SONGS-1 SEISMIC PROGRAM FOR LONG TERM SERVICE

Responses to Action Items Resulting
From the 02/12/85 and 02/27/85
Meetings with the NRC.

SOUTHERN CALIFORNIA EDISON COMPANY

March 11, 1985

Flow Chart of Seismic Program for LTS

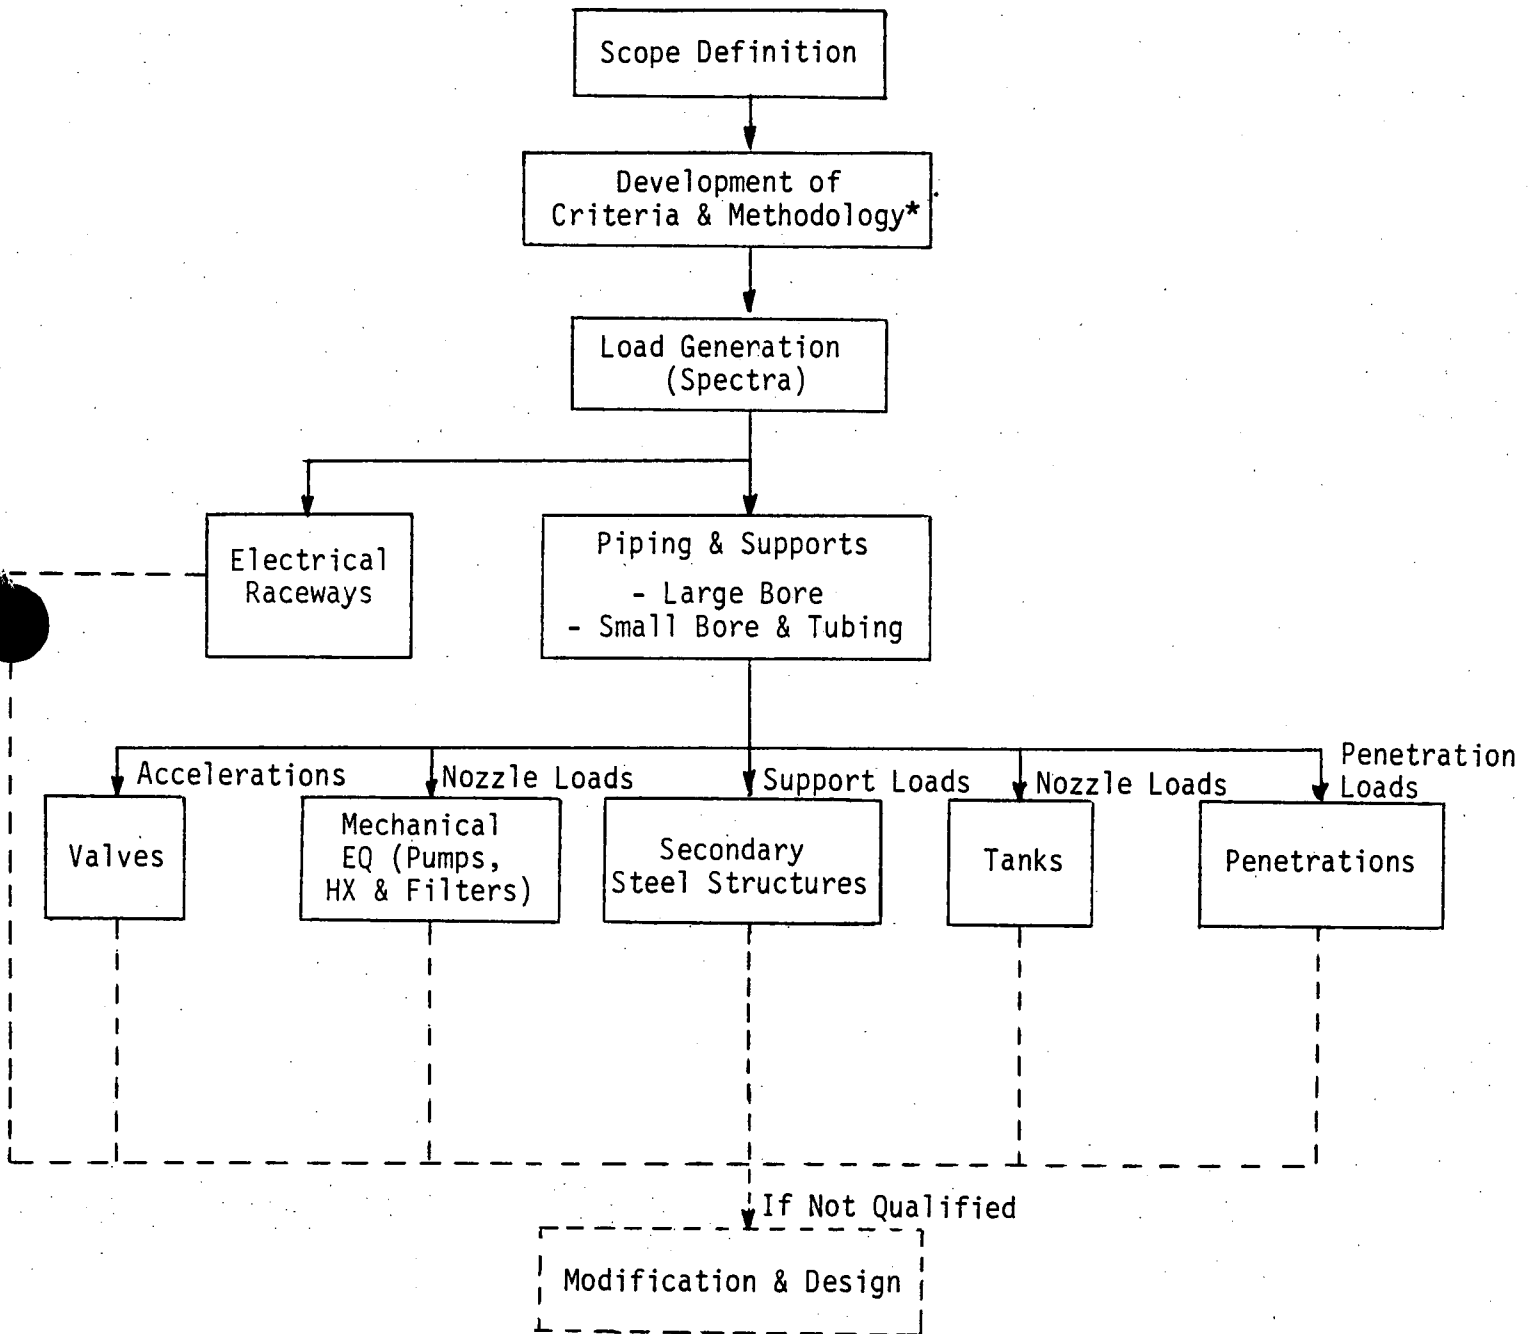
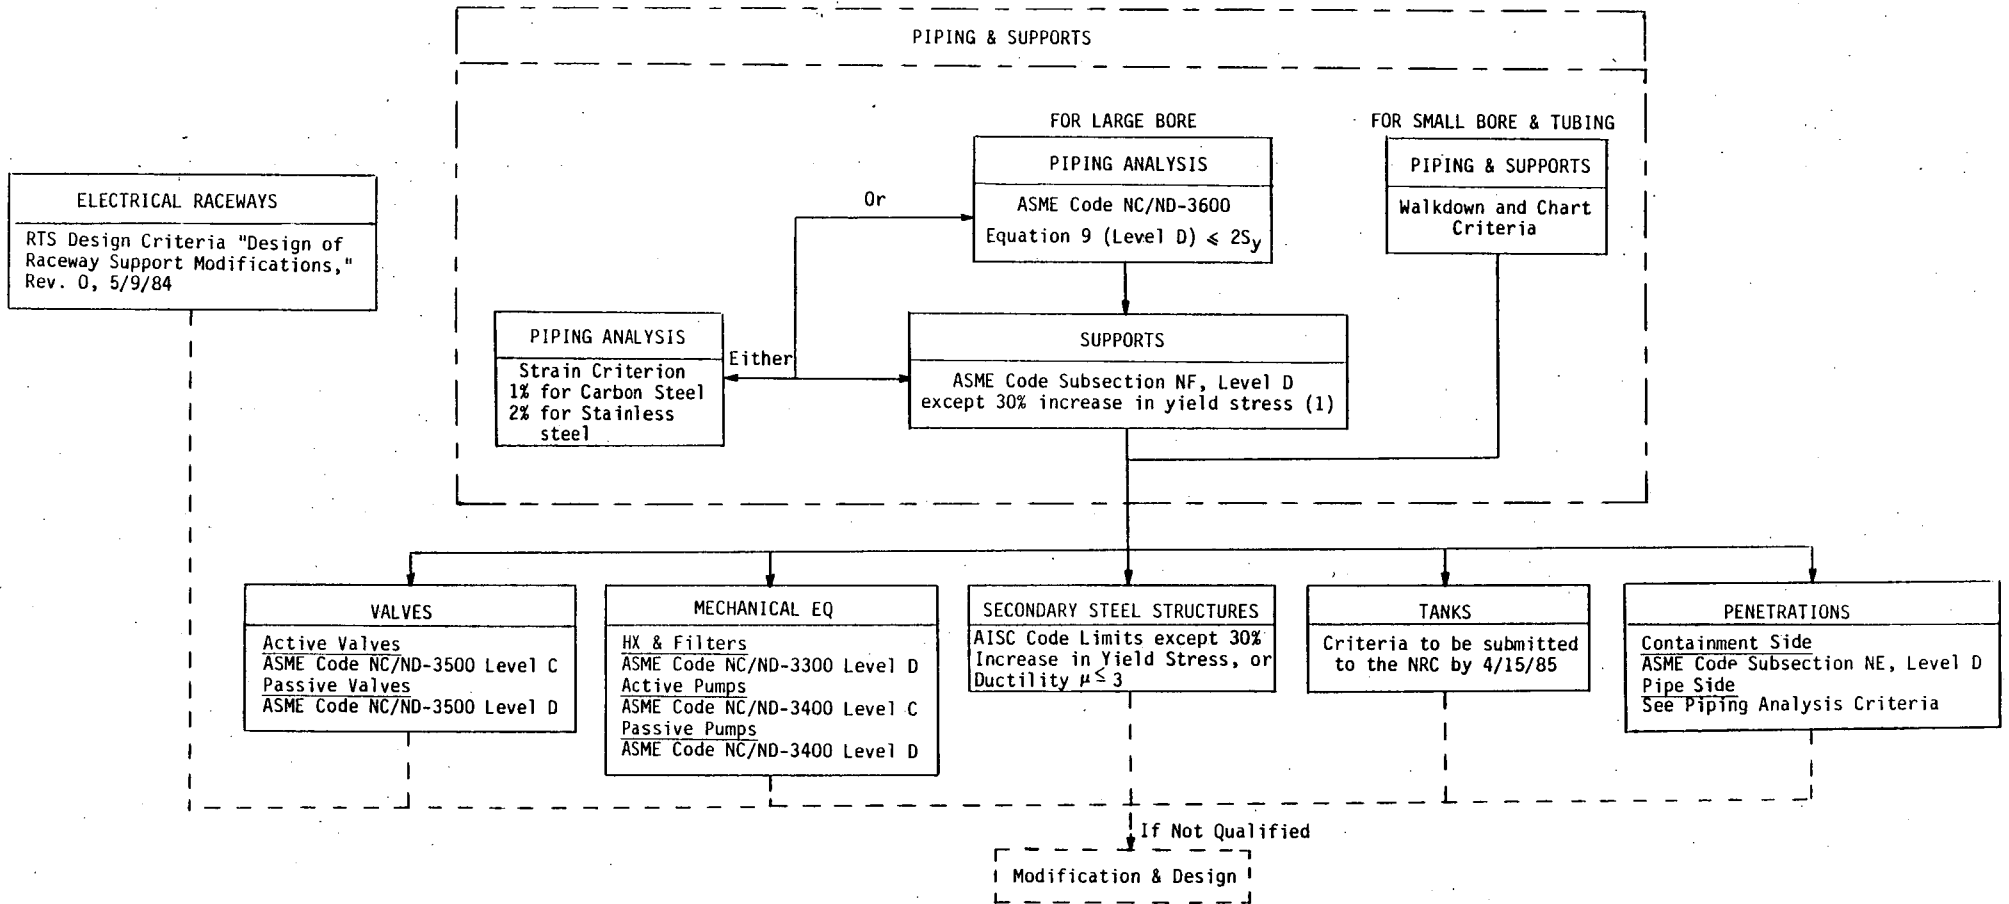
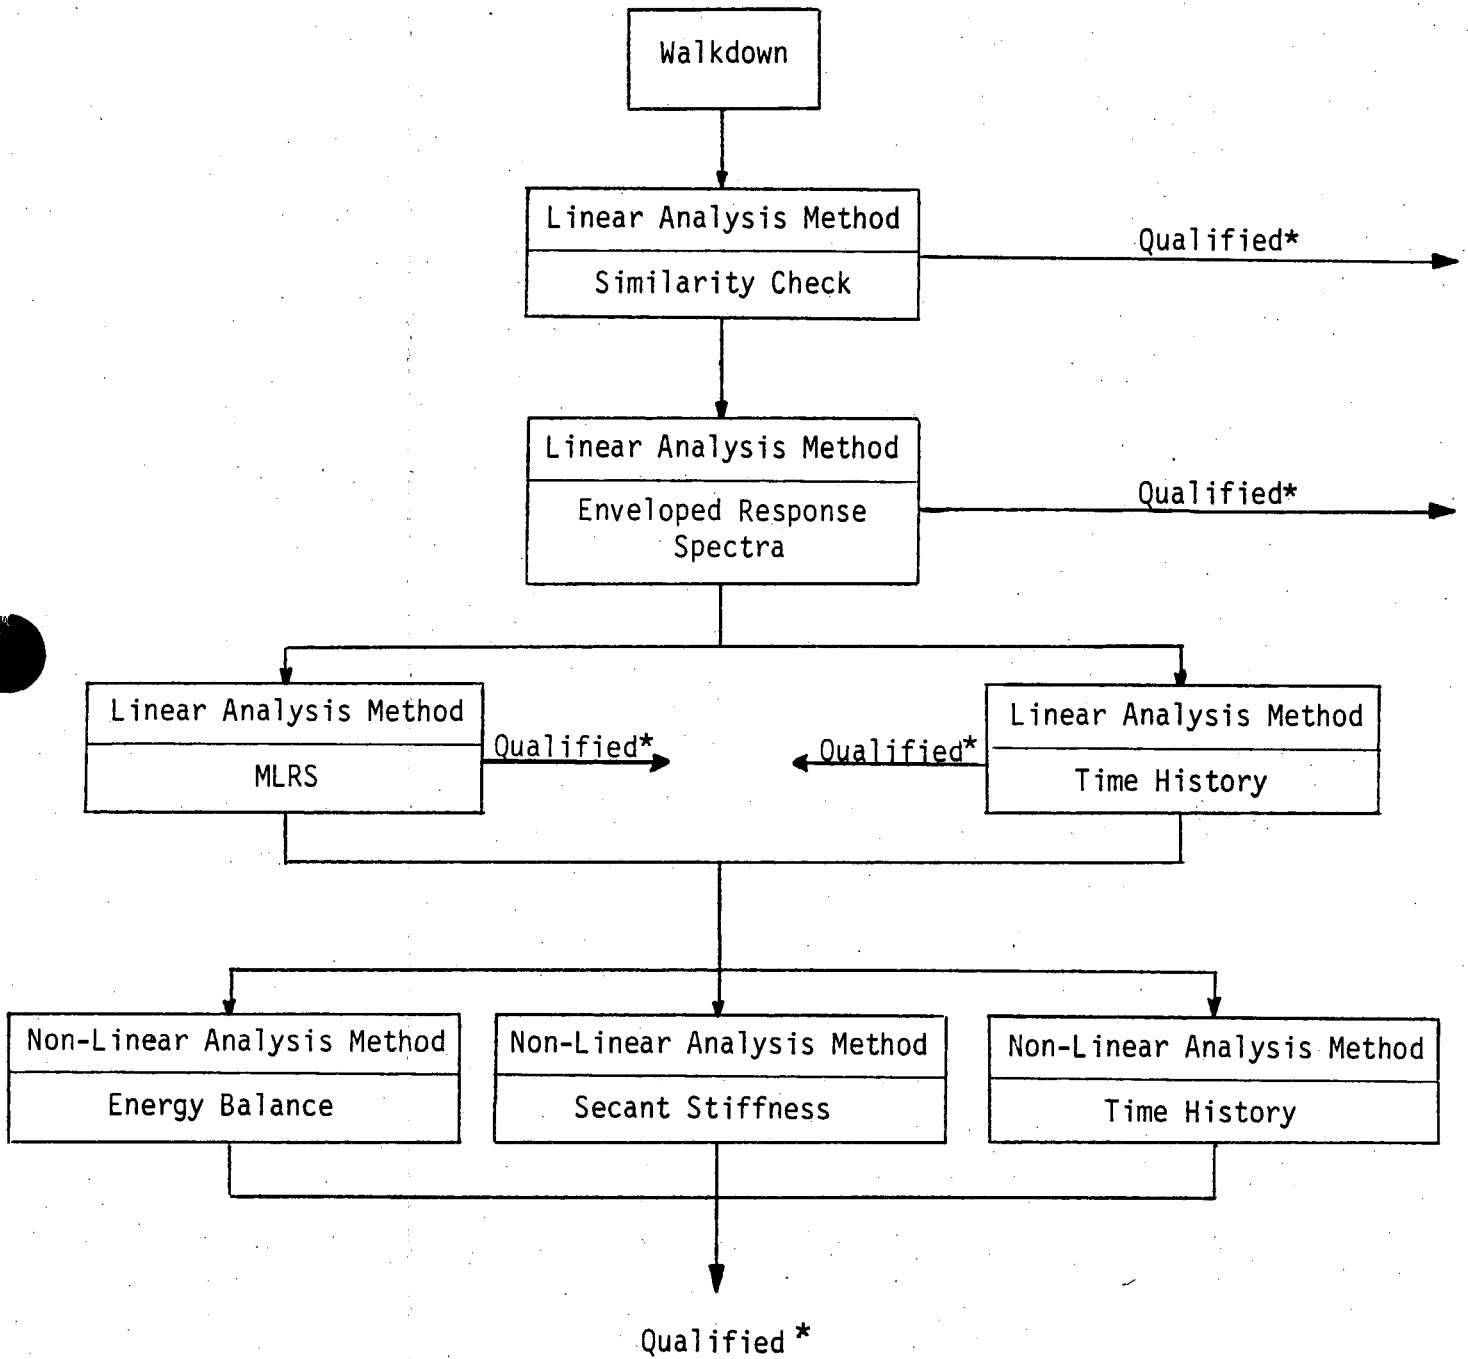
ACTION ITEM 1: Provide flow charts showing the flow paths for the LTS methodology, including use of criteria.

Criteria Flow Chart

Methodology Flow Chart for Piping & Supports Qualification (Large Bore)

FIGURE 5.1 AC-19 Mathematical Model - Nonlinear Analysis

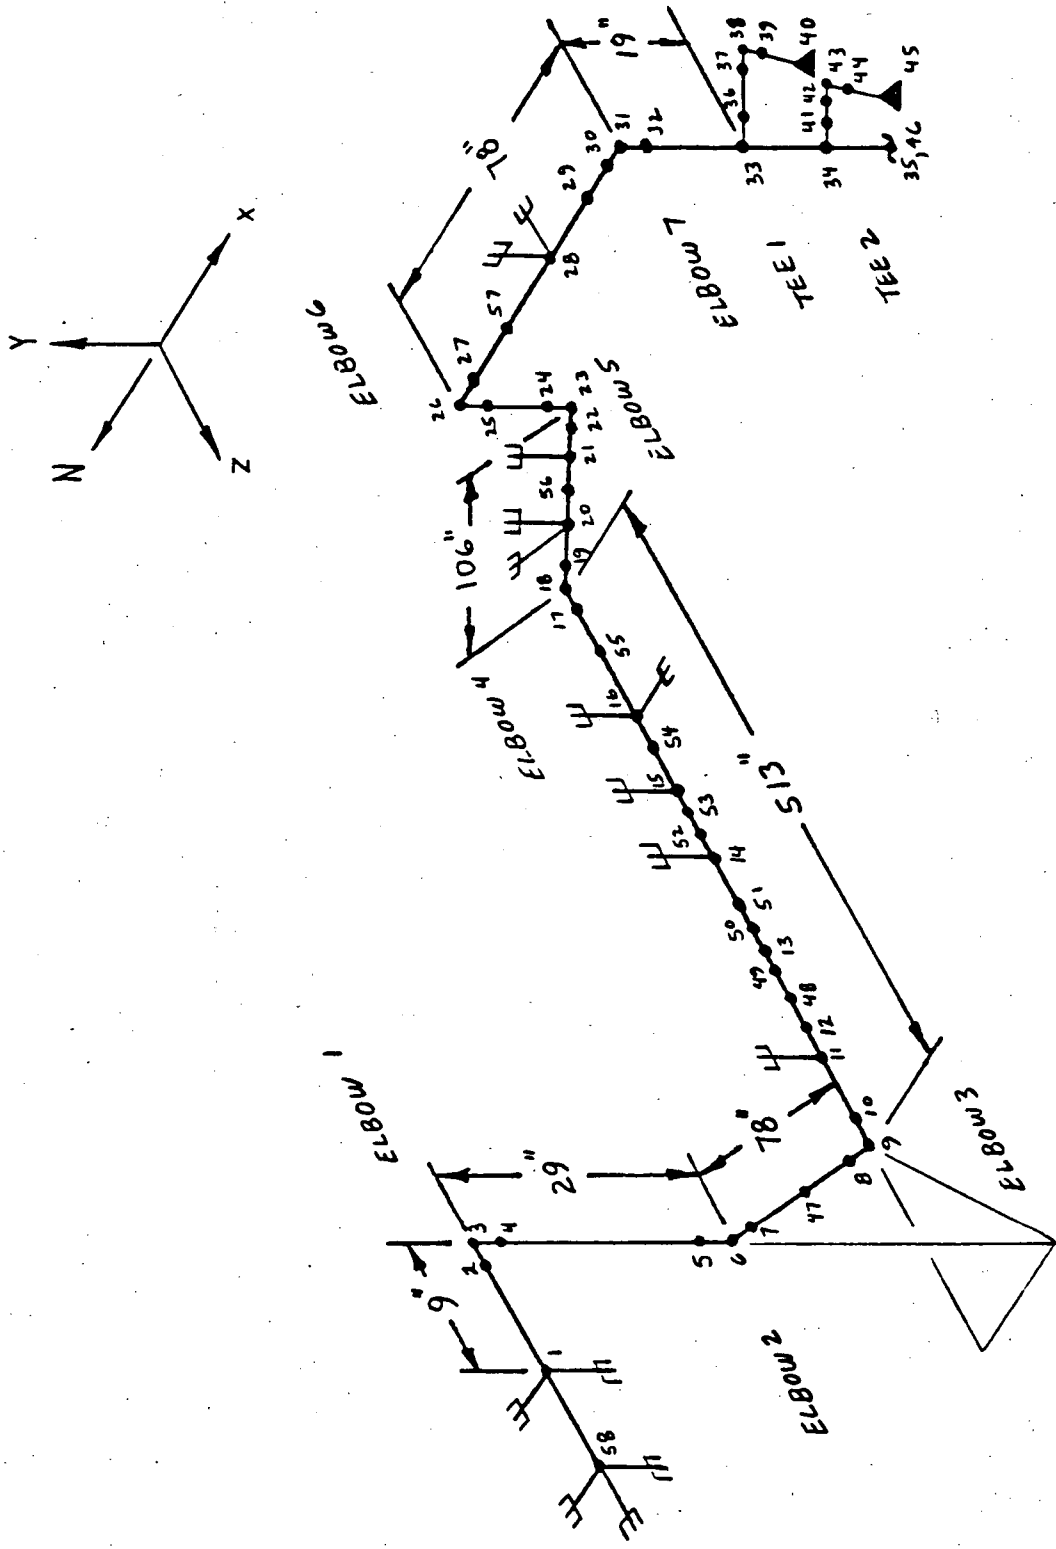
5. Provide a justification for 2 percent strain limit for stainless steel. Also, provide additional information for the use of 2.0Sy as the allowable for elastically calculated primary stresses under Level D loadings.

The purpose of the nonlinear analyses performed for SONGS-1 [1] was to show that typical piping systems remain functional at an elastically calculated stress limit of 2S_y. The load combination considered in the analysis was pressure, gravity and seismic inertia.

Numerous hot safe-shutdown piping systems were reviewed and two representative piping systems (AC-19 and MW-01) were selected for the study. The two systems provided a good representation of the various piping components, materials, and system types represented in the plant. Both carbon and stainless steel materials were considered, as well as piping components of different sizes and flexibilities. Both systems have typical run configurations with a mix of various component types. Although the seismic stress levels in the systems were not at the functionality stress limit of 2S_y, the input motions were increased to obtain the desired maximum elastic stress.

<u>Location (See Figure 5.1)</u>	<u>Linear Analysis Stress, ksi</u>	<u>Nonlinear Analysis Maximum Strain, Percent</u>
Elbow 1 @ Node 2	49.7	0.49
Elbow 2 @ Node 7	39.6	Remained Elastic
Elbow 3 @ Node 8	69.4 (2.0 S_y (1))	0.74
Pipe @ Node 14	53.8	0.21
Pipe @ Node 16	77.5 (2.2 S_y (1))	0.41
Tee 1	86.6 (2.5 S_y (1))	Remained Elastic ⁽²⁾

Figure 1 - Typical Support Reaction Time History

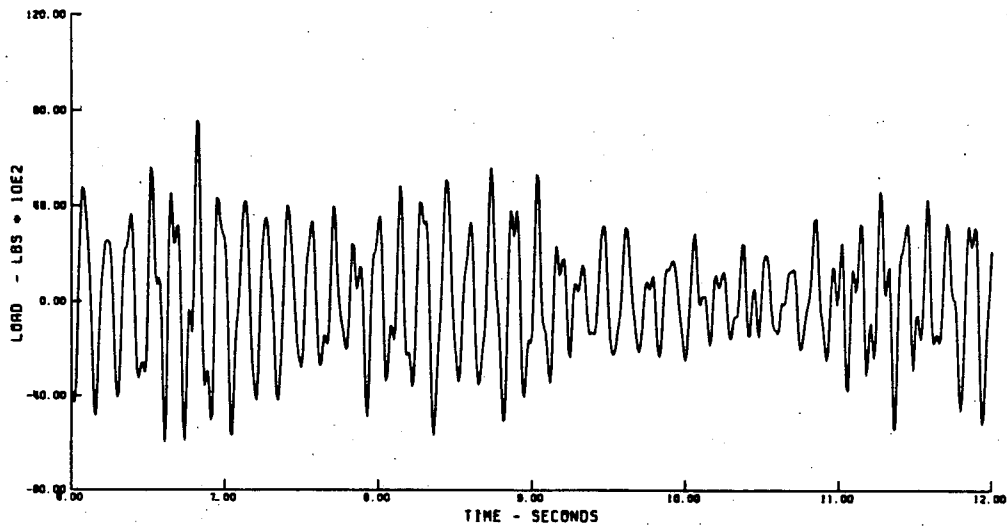
ACTION ITEM 9: Provide a detailed justification for the 10 percent strength increase for strain rate effects.

For pipe supports and supporting structural steel members, the seismic loading is a result of the pipe's excitation. Piping fundamental frequencies are usually in the range of 2-10 Hz. A typical pipe support reaction time history is shown in Figure 1. This shows the predominant response at about 6 Hz and a higher mode response superimposed at about 12 Hz. This figure demonstrates that the load rate (proportional to strain rate) is significant even at high load levels. A sample calculation is given below for this support's reaction time history to estimate the strain rate.

Figure 1 - Yield Strength Distribution for A-7 Steel
(Reference 4)

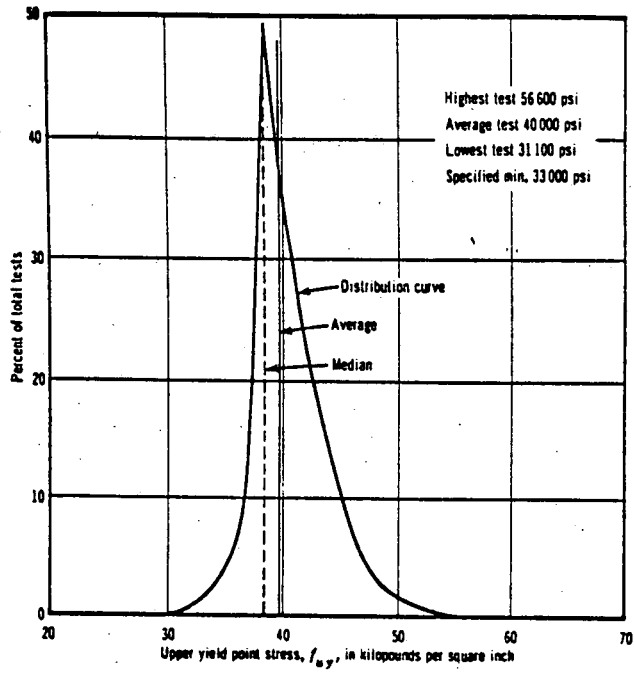
ACTION ITEM 10: Provide information on the 18 percent overstrength factor for structural steel. The presentation should include information on the statistical variation in the test samples.

ASTM specifications for structural and reinforcing steels require that the specified yield value represents a 3-sigma lower bound from test results [2]. The effect of this requirement is illustrated in Figure 1, which shows a probability distribution for yield strength of A-7 (similar to A-36) structural steel taken from a large sample of mill tests. The average yield strength is about 21 percent greater than the specified minimum value.

PROBLEM

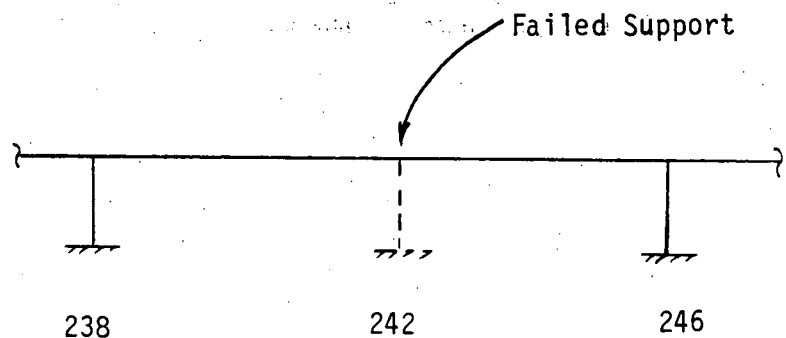
ACTION ITEM 16: Provide a sample calculation to show the application of the energy balance method and load redistribution from a failed pipe support.

A rigid Y support at data point 242 fails. Show pipe functionality without this support. In addition, evaluate increased support loads on adjacent Y supports.

1. Evaluate increased gravity and seismic loads on adjacent supports at data points 238 and 246. To evaluate the new seismic load, estimate the revised piping frequency without the support at data point 242. Using this frequency, estimate the seismic spectral acceleration from the floor spectra and evaluate the new seismic load.

Figure 1. Definition of Boundaries for Containment Penetration

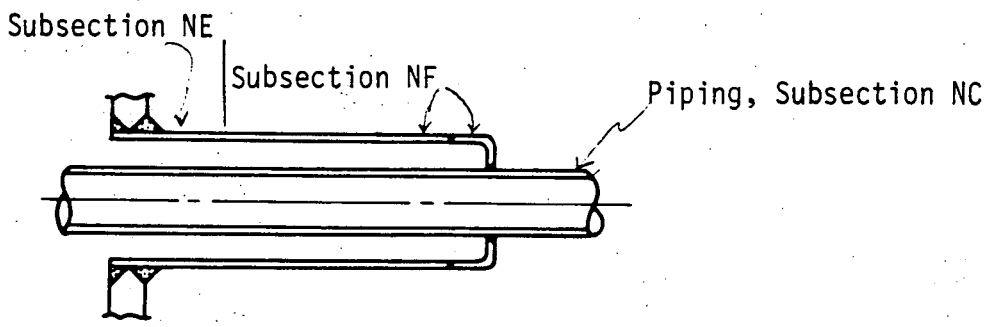
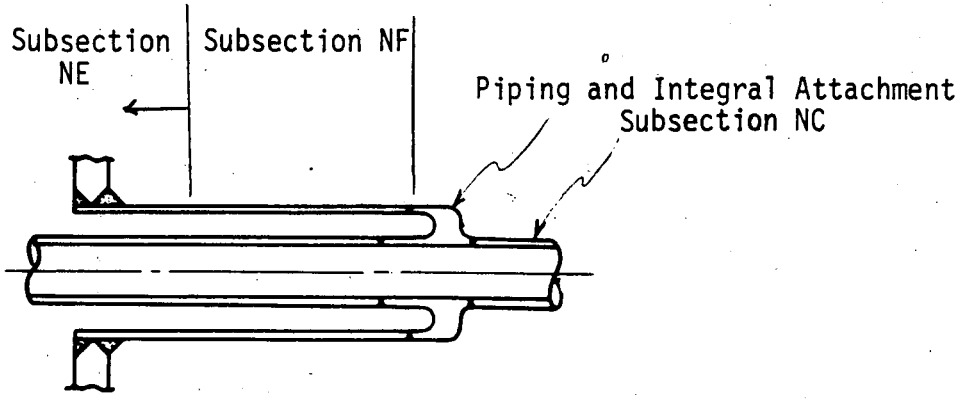
ACTION ITEM 18: Provide a definition of the boundaries to be used for seismic analysis of the containment penetrations.

- (a) Piping Segment: The piping analysis criteria and methodology developed for LTS will be utilized.
- (b) Containment Penetration Segment: The criteria of NE-3200 are applicable and standard analysis techniques (finite element, WRC-117) will be used to evaluate the penetration.
- (c) Intermediate Portion: The criteria and methodology for evaluating component supports developed for LTS will be utilized.

This approach will provide for the Code qualification of the containment penetration, the qualification of the piping, and demonstrate the load-carrying capability and structural integrity of the penetration to act as a piping support. The diagrams on the following page show the boundary definitions for criteria and analyses. The MC boundary extends a reasonable distance from the containment to ensure the integrity of the containment. In addition, for penetrations which include expansion joints, the displacement limits of the bellows are determined and the penetration will be evaluated to ensure that the displacement limits are satisfied.
